Appeal of Planning Commission Resolution No. 26-05 Regarding Coastal Development Permit No. 19-012 (25200 Pacific Coast Highway, APNs 4459-013-021 and 4459-014-018; Owner, PAR PCH, LLC; Appellant, Jun Hall for Concerned Citizens of Malibu Road, Inc.)

Malibu City Council
Special Meeting Agenda

Wednesday, August 19, 2026

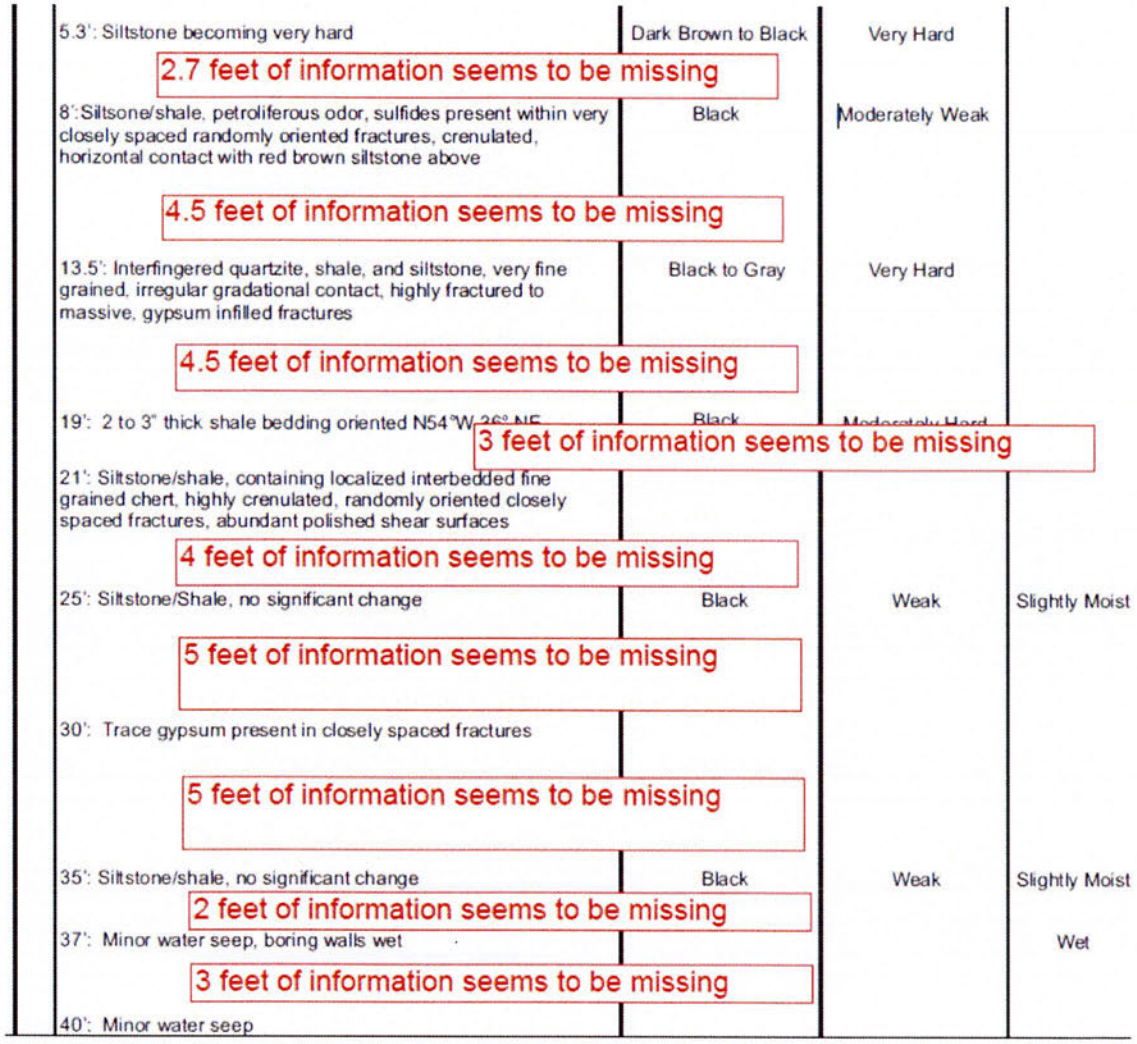
The concerns regarding the characterization of subsurface materials in Feffer's borings remain unaddressed. Specifically:

- Older consultants' reports documented crushed, disturbed, or sheared materials consistent with landslide deposits, while Feffer logs classify similar intervals as "bedrock" without explanation.
- Gaps in log descriptions at depth and a lack of detailed material characterization were not addressed and did not meet the industry standard of care.
- No explanation was provided for discrepancies between historic logs and Feffer's own interpretation.

As stated in the prior technical letter, continuous subsurface investigation is critical to defining landslide geometry and failure mechanisms. Continuous boring logs are essential. Industry standards require logging every vertical inch of the borehole and documenting lithology changes, shear zones, bedding attitudes, fractures, clay seams, and disturbed materials. Terms such as *smashed*, *jumbled*, *pulverized*, *reworked*, *slickensides*, and *polished shear surfaces* are commonly used to describe materials disturbed by landslide movement.

***Figures 7 & 8:** Appellant's photos which are clearly taken from the applicant's property and not from PCH, as is claimed in figure 8.*

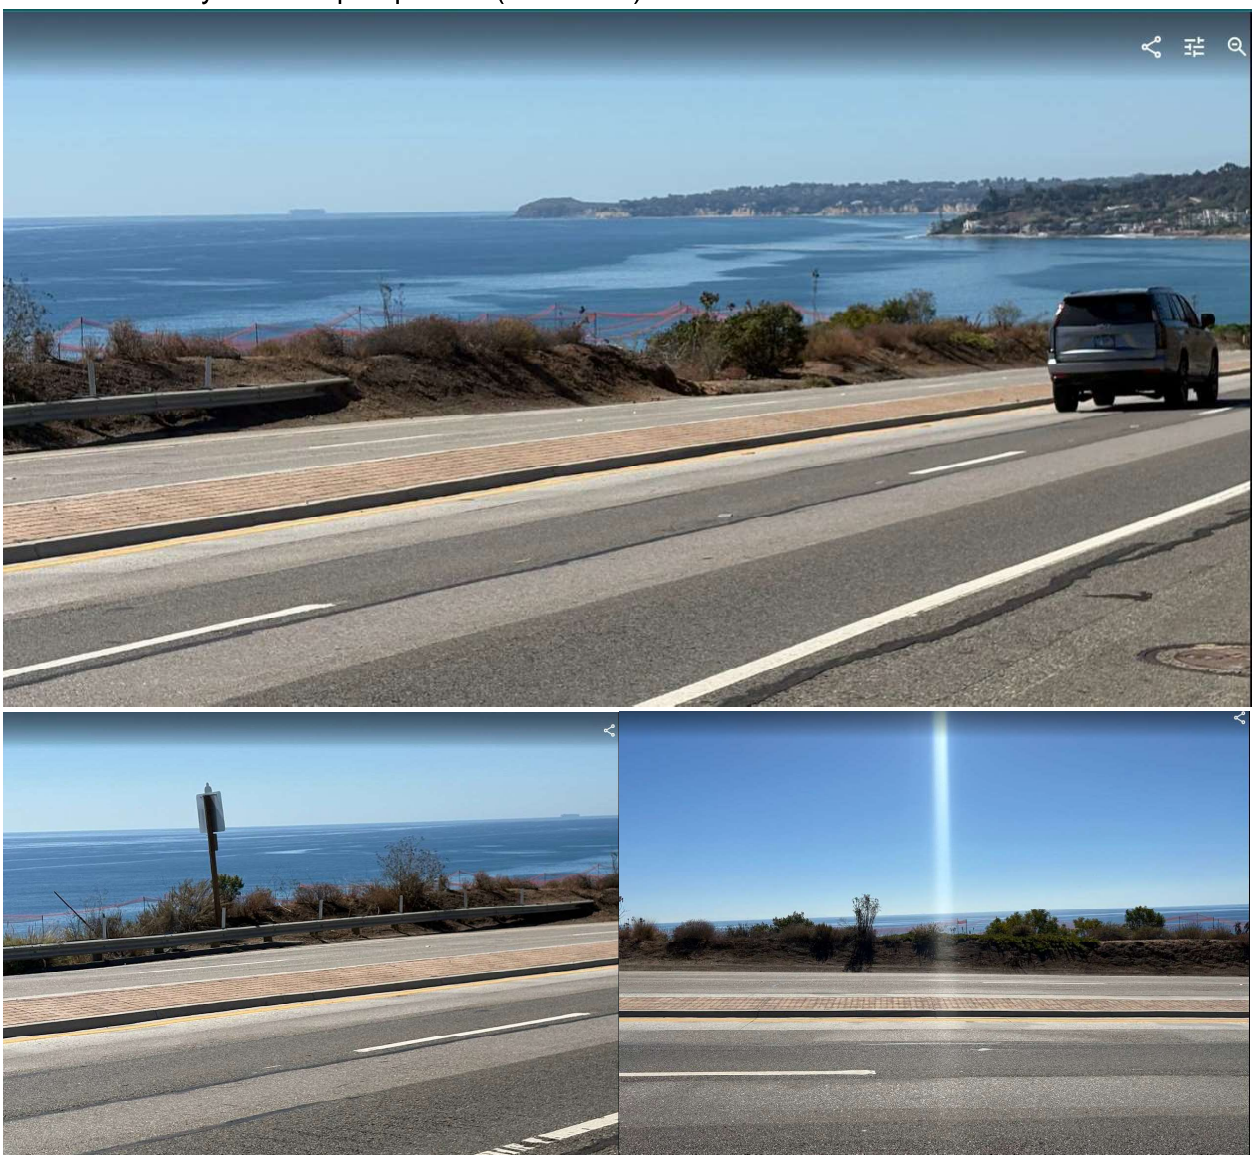
Again, the applicant's photos accurately show the relevant elevations of the story poles vis a vis the PCH roadway and berm. The applicant's photos below and the project rendering provide a clear picture of the minimal view blockage of the house design. Planning staff viewed the poles from PCH, photo documented the same and reviewed the applicant's renderings and have found them reliable and accurate as verified by staff's visits to the property. The appellants assertion

that the house blocks all views of Catalina and Palos Verdes is a contrivance supported by photos taken +-11' below PCH. The photos immediately below, taken by the applicant's representatives, show an entirely different perspective (from PCH).

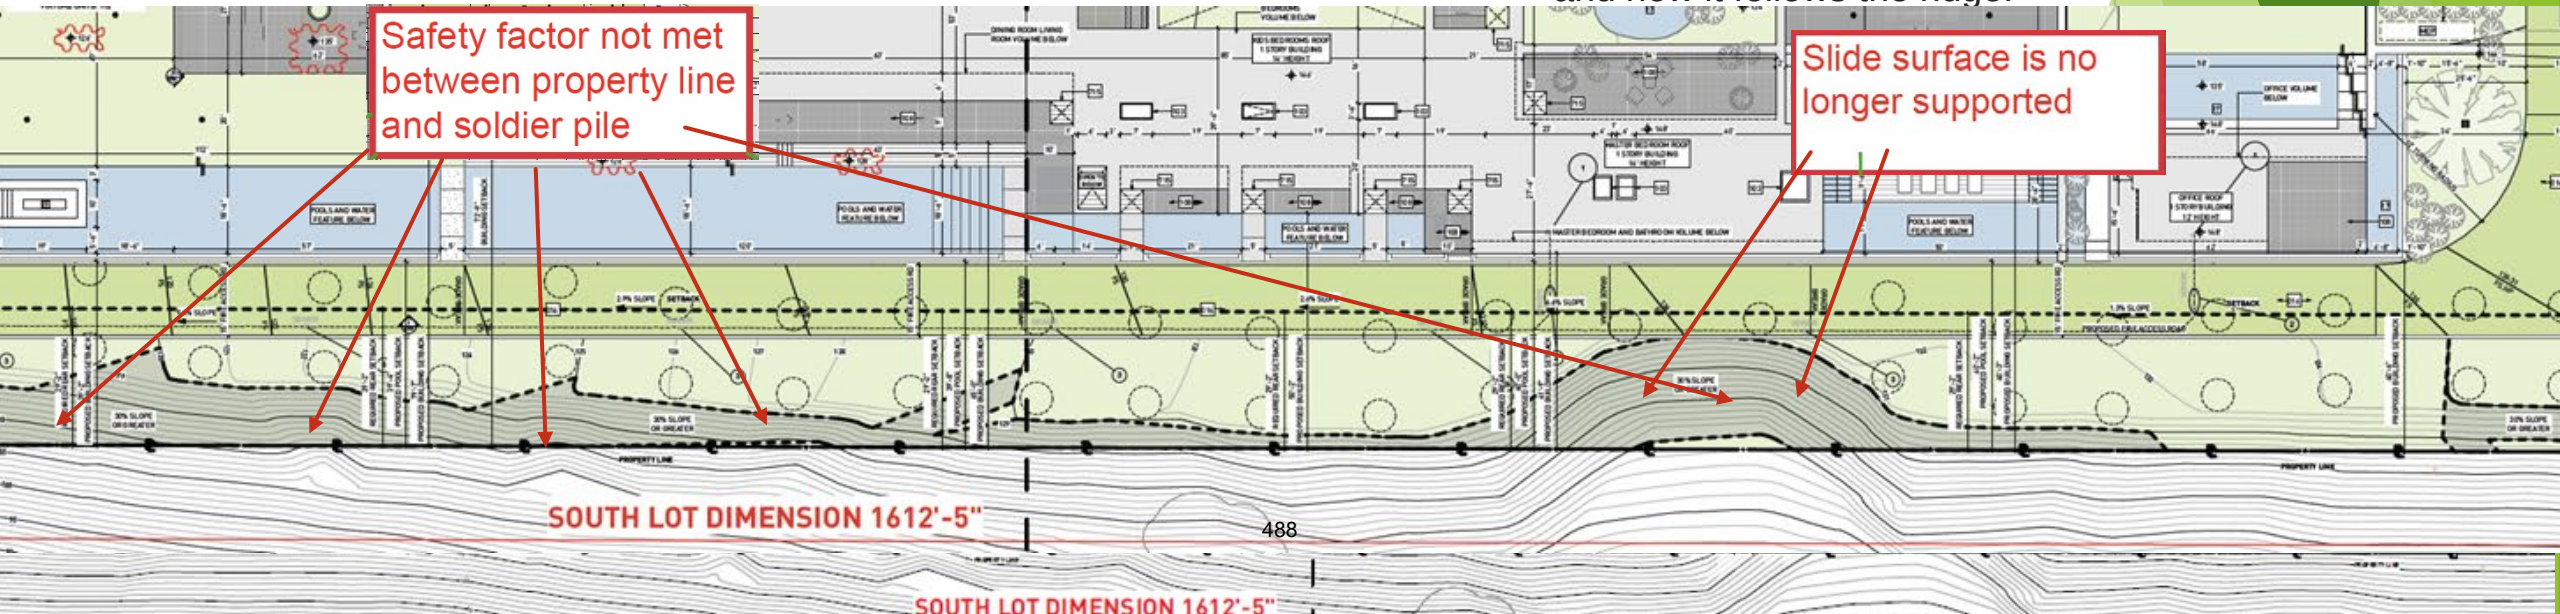
This is where the safety factor is clearly not met – They **moved/relocated** the soldier piles a few feet to avoid a slope variance and now they need a variance because there is space between the property line and the soldier piles where the safety factor is not met.

In addition, they are no longer supporting the slide in front of the MASTER area, and this would cause a slide into adjacent properties. This first image is before they moved the piles and shows the property line, it used to follow a straight line and now it follows the ridge.

Very FAR OFF the required 1.5 static factor of safety

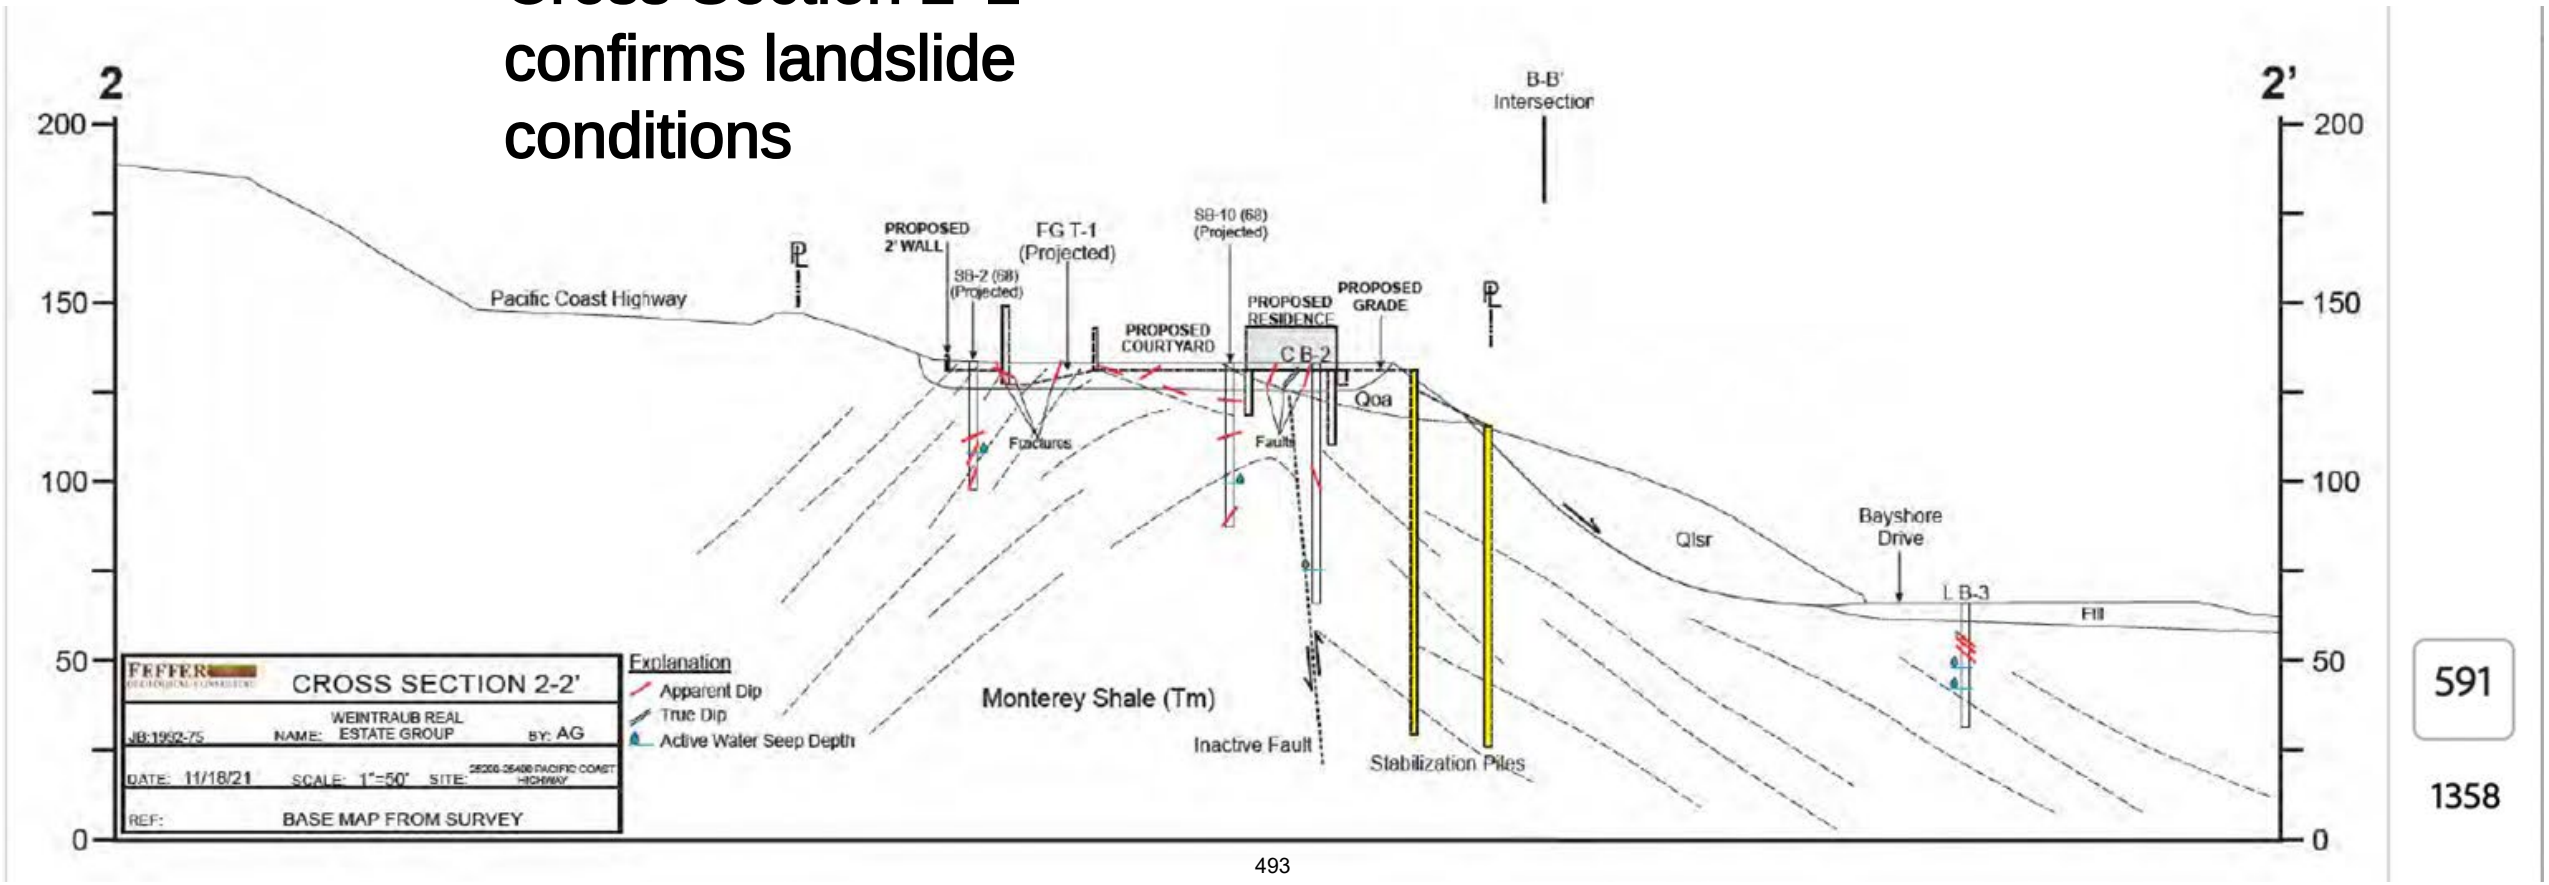
- Required minimum (LIP §9.4(D)): **1.5 static**
- Calculated results: **1.076 - 1.234**
- Values near **1.0 = marginal equilibrium / instability**

Pile Base Elevation vs Slide Base Elevation

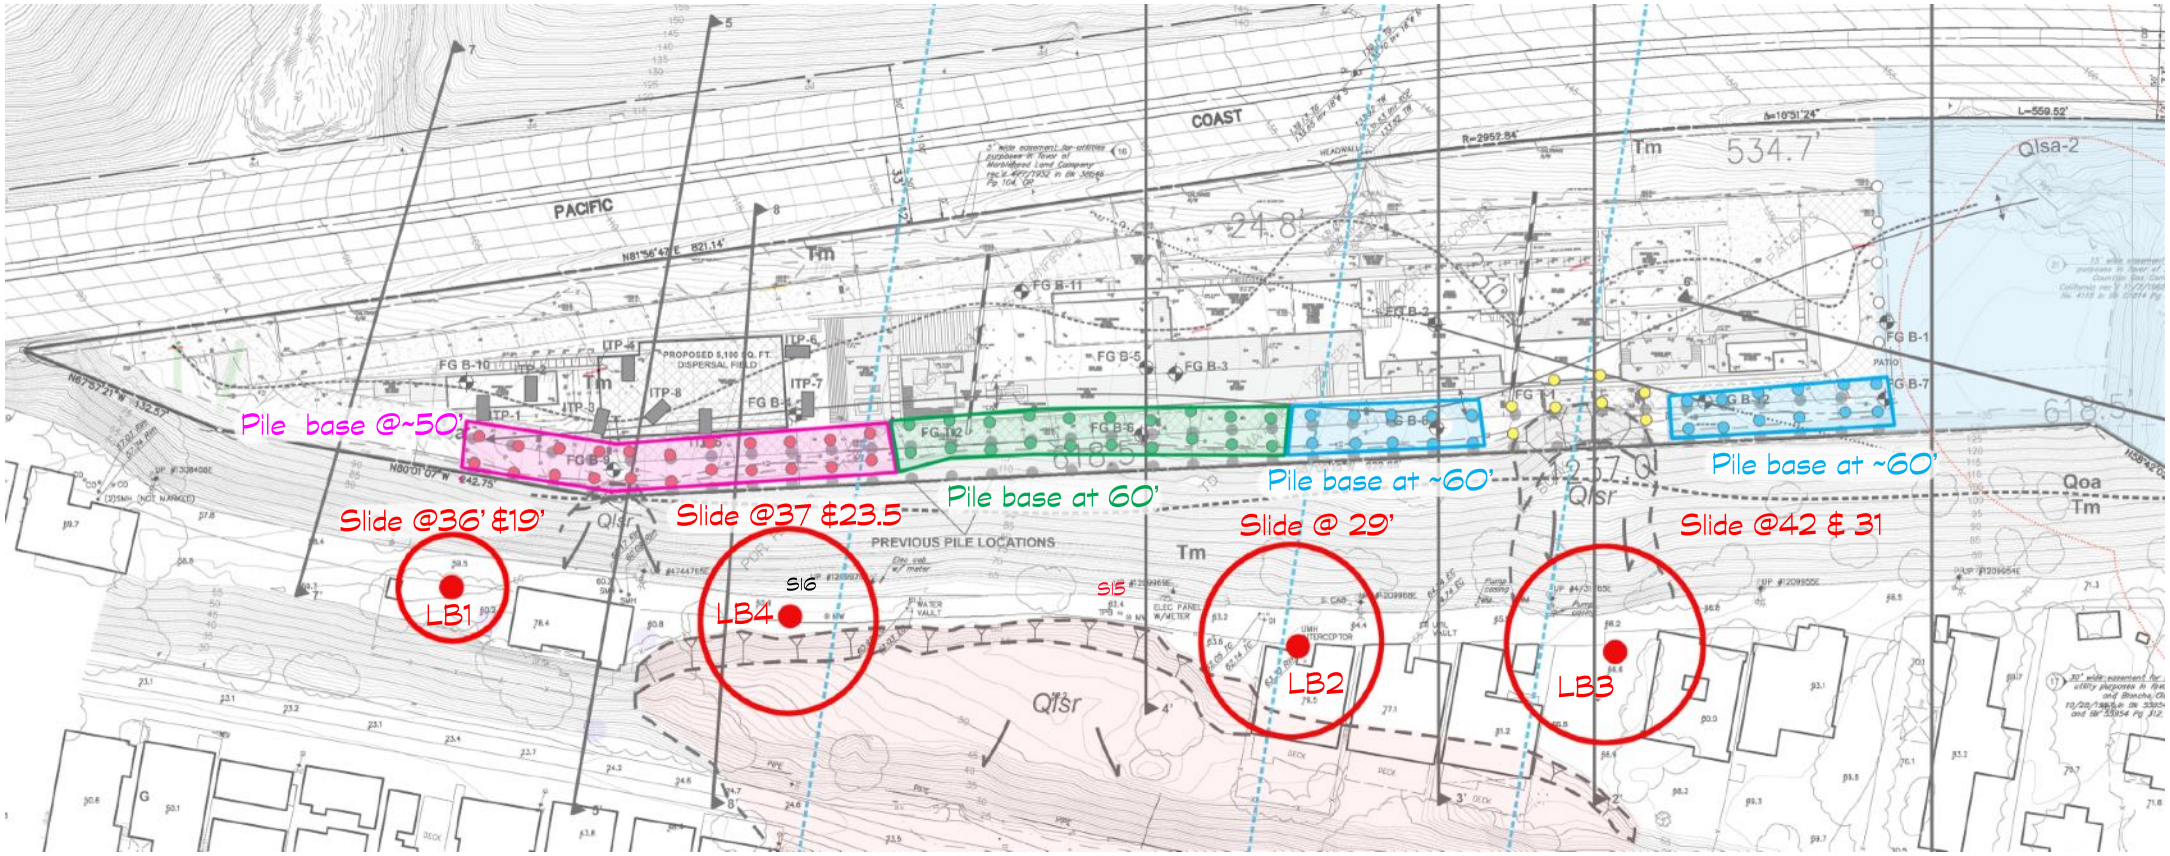
Table of pile depth vs. slide depth

Pile color from map	Red	Green	Blue and Yellow
Depth/pile length	50’	60’	60’
Bottom elevation of pile	50’	60’	60’
Slide Plane Elevation	36’& 19’/37’23.5	37’-29’	29’-31’
Deficit	14’ to 31’	36.5’-31’	31’-29’
